REL MEETING ON SAN ONOFRE 3 & 3
LOS ANGELES, CALIFORNIA
JULY 28-29, 1970

SUMMARY

SAN GEOFRE NUCLEAR GENERATING STATION
UNITS 2 AND 3

Figure A.
Bathymetry profile of continental margin, San Onofre. (See Figure C for location.)

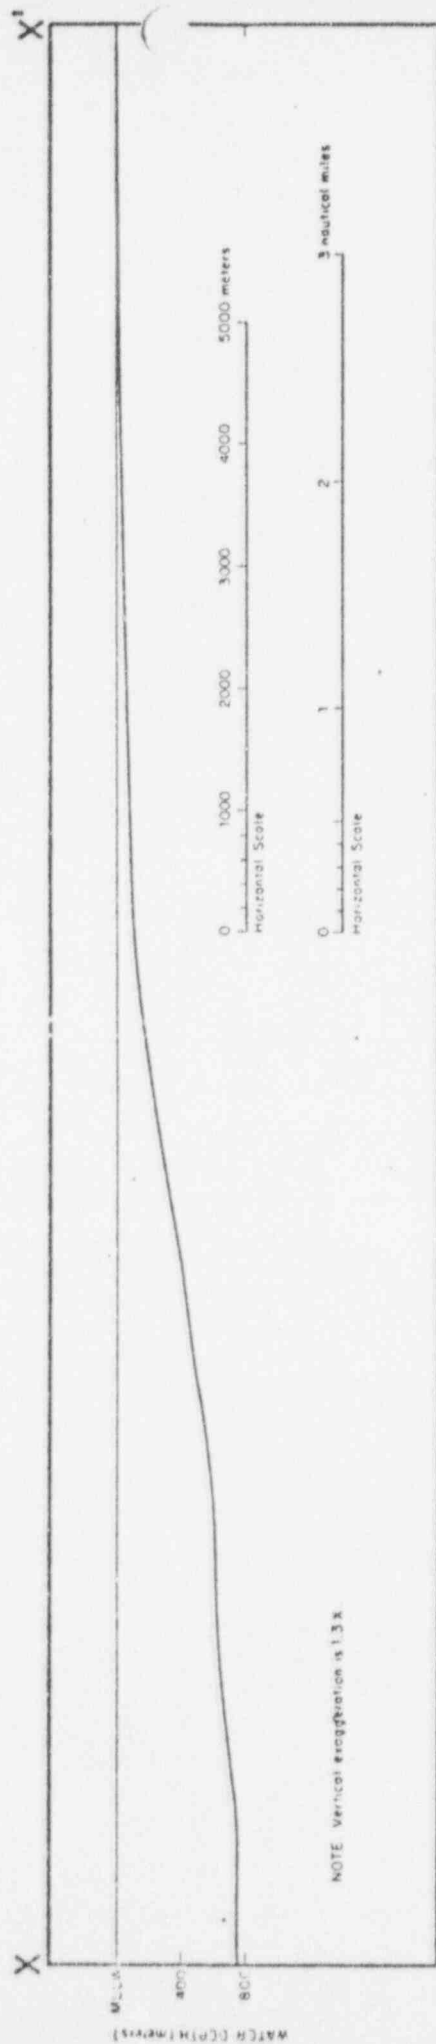
The attached profile shows the ocean bottom profile off San Onofre out to the base of the continental slope. The drawing illustrates the gentle bottom slopes of less than 1° out to a depth of about 100 meters. Beyond this point out to depth of about 800 meters the slope is about 5° . The flat slopes and consolidated nature of the offshore sediments preclude the possibility of offshore landslides which could affect the plant.

Figure B.
Geologic cross section of continental shelf, San Onofre. (See Figure C for location.)

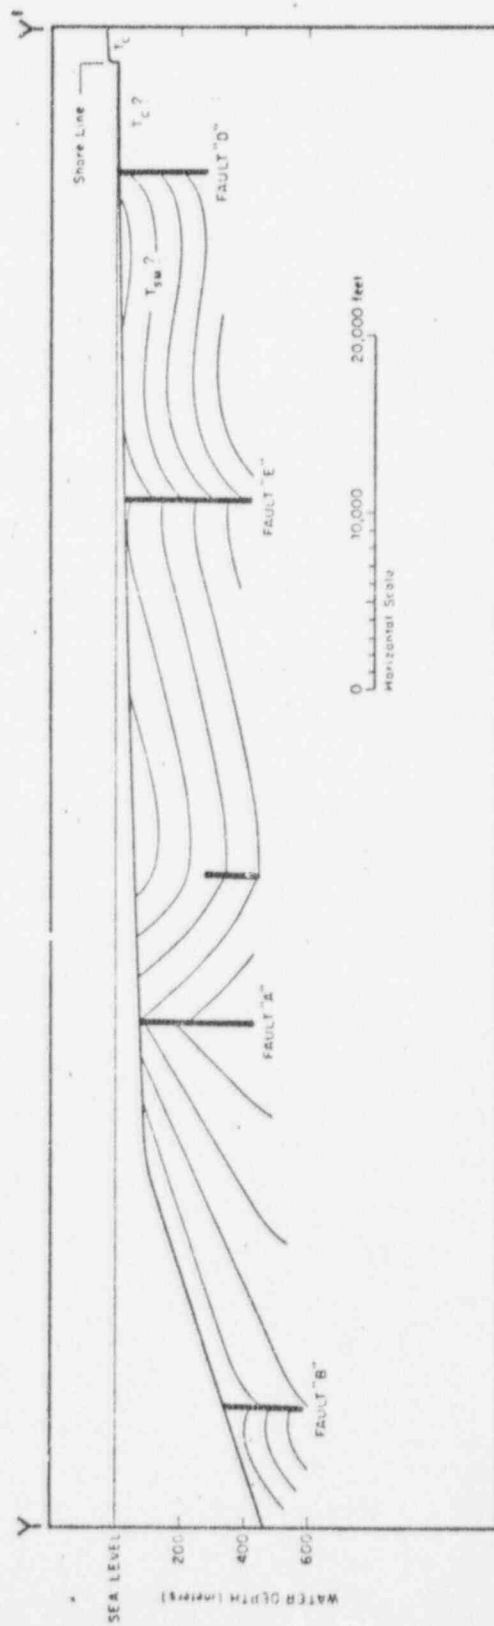
The Sparker profiles, S-21 and S-26, parallel the coast. They are believed to have been run within a disturbed zone of a fault, labeled "D." (No Sparker traverses crossed normal to Fault "D," so the width of the disturbed zone or the exact location of the axis of the fault was not determined. Shallow water depth (less than 40 feet) hampered data acquisition across the fault and subsequent analysis of the seismic profiles.) The disturbed zone, labeled Fault "D," is interpreted to be the seaward extension of the Cristianitos Fault. Thus, the submarine continuation of the Cristianitos turns to the southeast and trends subparallel to the coast. The lack of evidence of faulting on Sparker records crossing the NNW-SSE offshore projection of the Cristianitos confirms that it does not strike diagonally across the continental shelf. The Fault trace must bend to the southeast or terminate just seaward of the sea-cliff exposure. The attached cross-section indicates the generalized geological interpretation of the offshore sparker data.

Figure 1. Geologic map of the Cristianitos Fault Reactor Dome Unit 1, showing faults A, B, C, and D, and seismic data points.

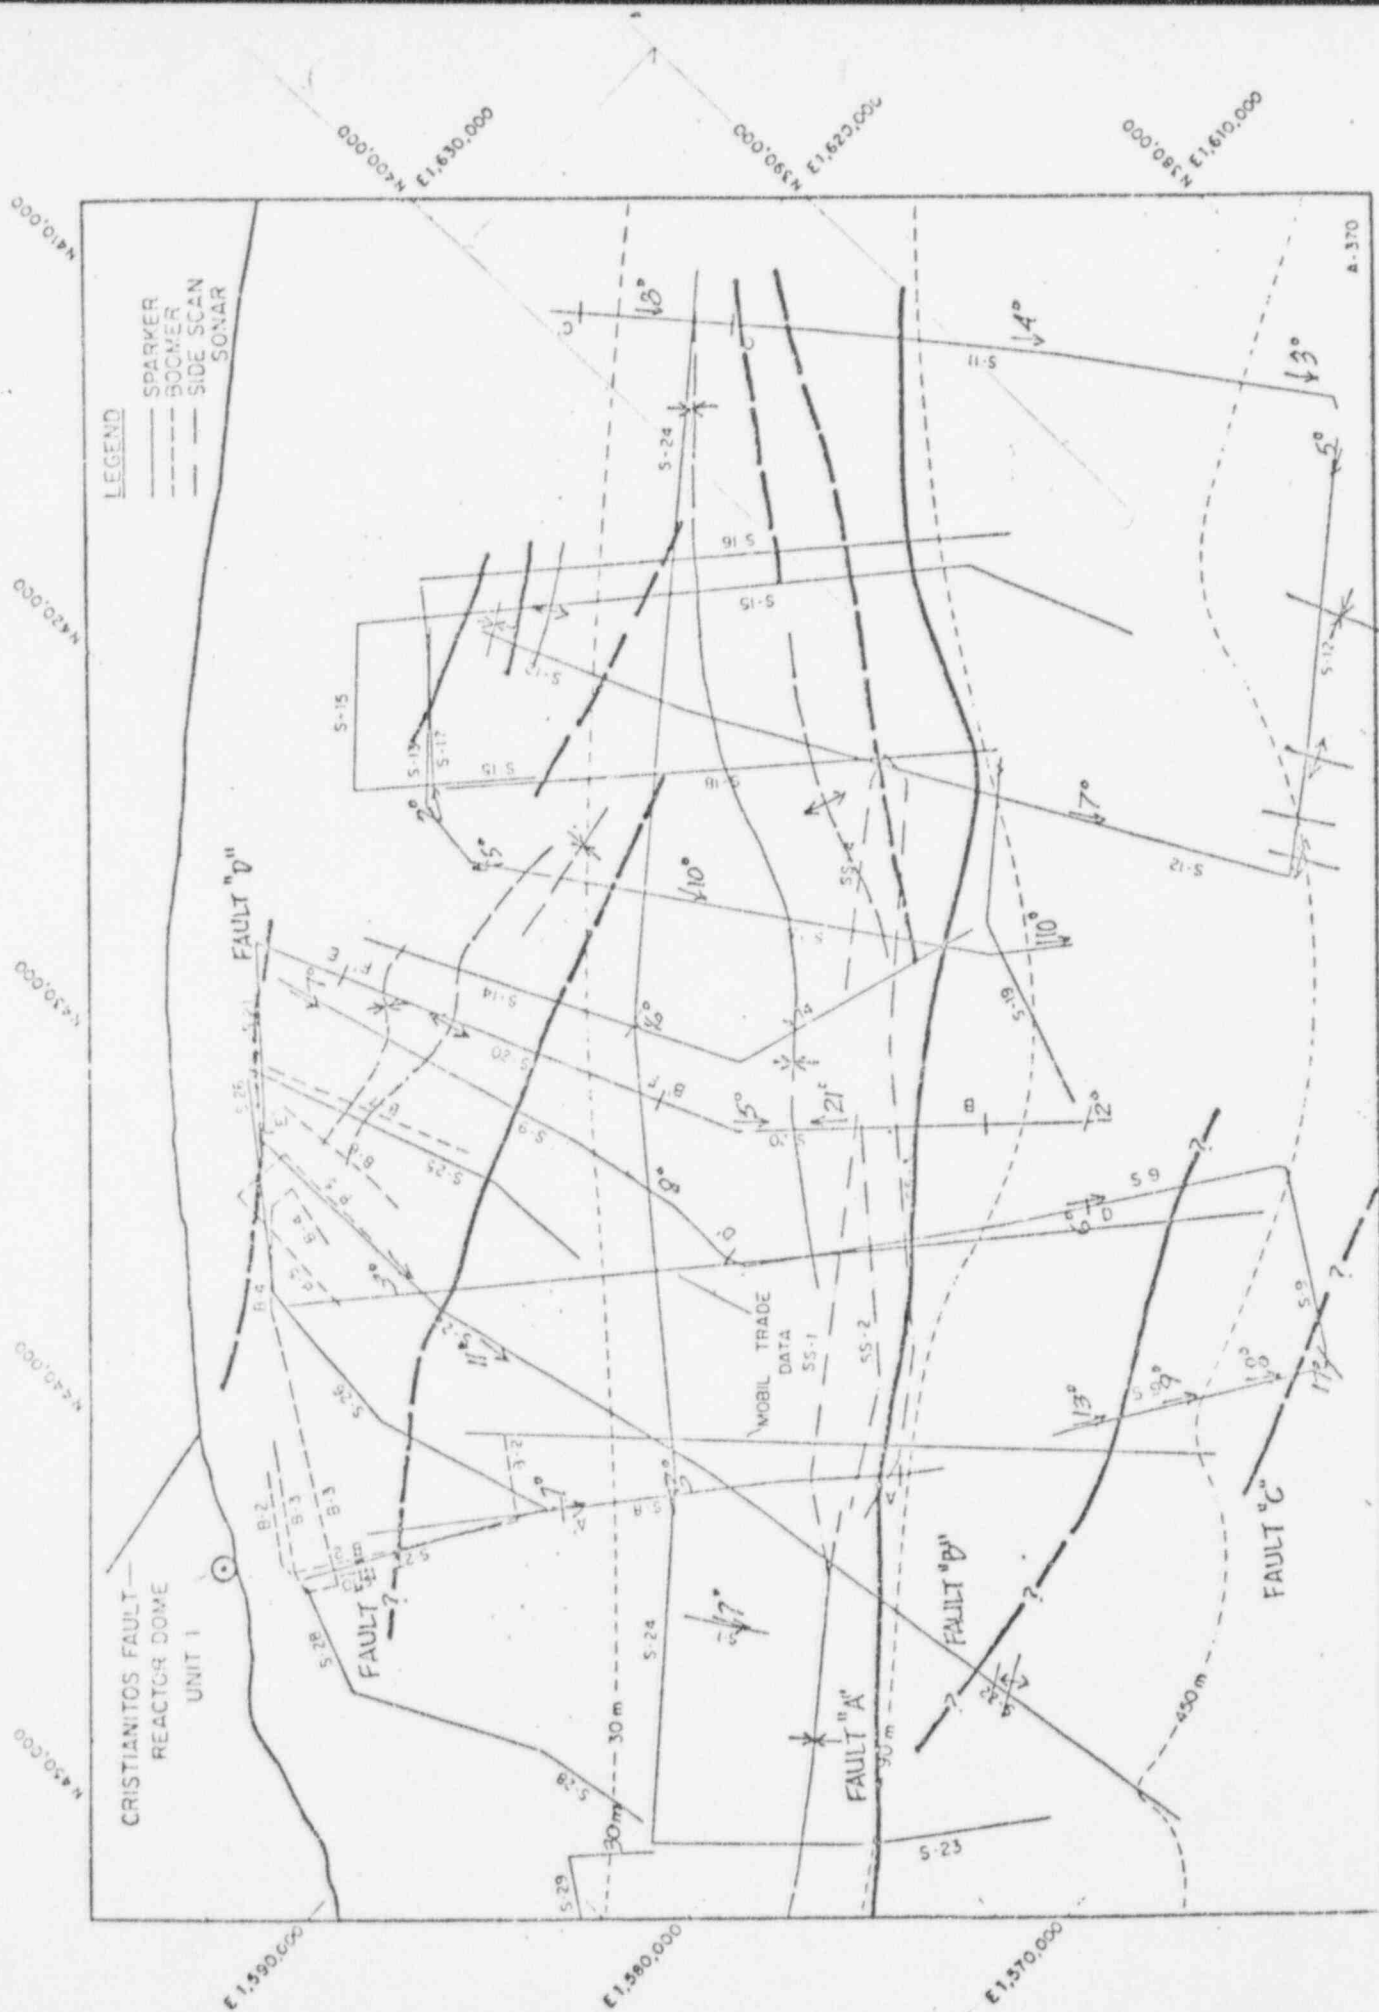
Seismic profiles south of San Onofre reveal that the Cristianitos Fault does not project offshore with its terrestrial NNW-SSE strike. Boomer lines B-4 through B-7 and Sparker profiles S-9, 14, 20, 22, 25, and 26 (Appendix 2-B, Figure 1) crossing the projected submarine extension of the Fault did not reveal any structural breaks that could be interpreted as the Cristianitos.

However, southwest of the seal-cliff exposure of the Cristianitos Fault, a distinct change in acoustic appearance and an increase in effective depth of seismic penetration from about 700 feet to about 1400 feet on Sparker profiles, S-21 and S-26 (Appendix 2-B, Figures 1 and 10) indicate a significant change in sediment lithology that trends nearly parallel to the coast. Such a change in terrestrial lithology occurs at the Cristianitos Fault where the San Mateo and Capistrano Formations are juxtaposed by normal faulting (Converse, Davis and Associates, 1970), and this offshore change is probably the Cristianitos Fault.
